# UNITED STATES PATENT AND TRADEMARK OFFICE

APPLICATION NO.	FILING DATE	FIRST NAMED INVENTOR	ATTORNEY DOCKET NO.	CONFIRMATION NO.
10/560,223	12/12/2005	Haruhiko Ikeda	36856.1394	2555
54066	7590	03/19/2009		
MURATA MANUFACTURING COMPANY, LTD.				
C/O KEATING & BENNETT, LLP	EXAMINER			
1800 Alexander Bell Drive	SCARLETT, SHAKA S			
SUITE 200	ART UNIT			
Reston, VA 20191	2823			
	PAPER NUMBER			
	NOTIFICATION DATE		DELIVERY MODE	
	03/19/2009		ELECTRONIC

<b>Office Action Summary</b>	<b>Application No.</b> 10/560,223	<b>Applicant(s)</b> IKEDA, HARUHIKO
	<b>Examiner</b> SHAKA SCARLETT	<b>Art Unit</b> 2823

FIG. 3

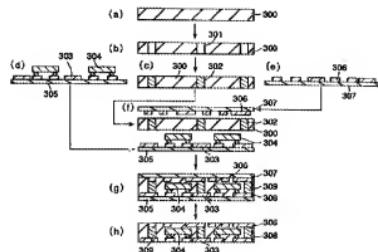
**Regarding Claim 8**, Nakatani et al. discloses a process for producing a component-embedded substrate, comprising the steps of: connecting and fixing a first electronic component (304) to a first electrode pattern (303) on a first supporting layer (305) with a conductive bonding material (Column 10, line 30 – 33; Column 9, line 13 – 15); press-bonding a second supporting layer (307) including a second electrode pattern (306) onto the electronic component-fixed surface (304)) of the first supporting layer (305) with a first prepreg (300) there-between to perform transfer (Column 10, line

42 – 45, line 51 – 56); separating the first supporting layer (305) and the second supporting layer (307) from the first prepreg (300) such that the first and second electrode patterns (303, 306) are disposed on a front surface and a back surface of the first prepreg (300) (Column 10, line 64 - 65); curing the first prepreg before or after the step of separating the first supporting layer and the second supporting layer from the first prepreg (Column 10, line 51 – 56); connecting and fixing a second electronic component onto a back surface of the second electrode pattern (306) (Column 11, line 7 – 10). Nakatani et al. discloses a multi-layer device constructed of a plurality of layers including electronic components mounted on electrodes with a prepreg in-between (see Fig. 4), wherein the electrodes are used for mounting electronic components and prepreg material (401b) is formed in-between. However, Nakatani et al. does not explicitly disclose connecting and fixing a second electronic component onto a back surface of the second electrode pattern with a conductive bonding material after the step of curing the first prepreg; press-bonding a third supporting layer including a third electrode pattern onto a second electronic component-fixed surface with a second prepreg there-between to perform transfer; separating the third supporting layer from the second prepreg; and curing the second prepreg before or after the step of separating the third supporting layer from the second prepreg, wherein the prepregs and the electrode patterns are sequentially laminated. Rather, Nakatani et al. discloses forming built-in modules in clusters.

Therefore it would have been obvious to one of ordinary skill in the art at the time of the applicant's invention to modify forming a built-in module using the process illustrated in Fig. 3 with a second electronic component on the electrode 306 (Column 11, line 7 – 10) of Nakatani et al. with a sequential process of Suzuki as it would provide the motivation to form a multilayered structure by repeating the lamination process (MPEP 2144.07). Modifying Nakatani et al. with Suzuki would produce a structure wherein after bonding the second electronic component to electrodes (306) (Column 11, line 7 – 10), the process disclosed in Fig. 3 may be repeated by press-bonding a third support (Fig. 3 (f), 307) with electrodes to the second electronic component fixed to electrode (306), curing, then releasing the support 307 to form a multilayered structure. The claim would have been obvious because a person of ordinary skill has good reason to pursue the known options within his or her technical grasp. If this leads to the anticipated success, it is likely the product not of innovation, but of ordinary skill and common sense (KSR International Co. v. Teleflex Inc., 82 USPQ2d 1385 (U.S. 2007)). The process of repeating a single process as disclosed in Suzuki for forming a multilayered component-embedded device is evident this process is well-known and
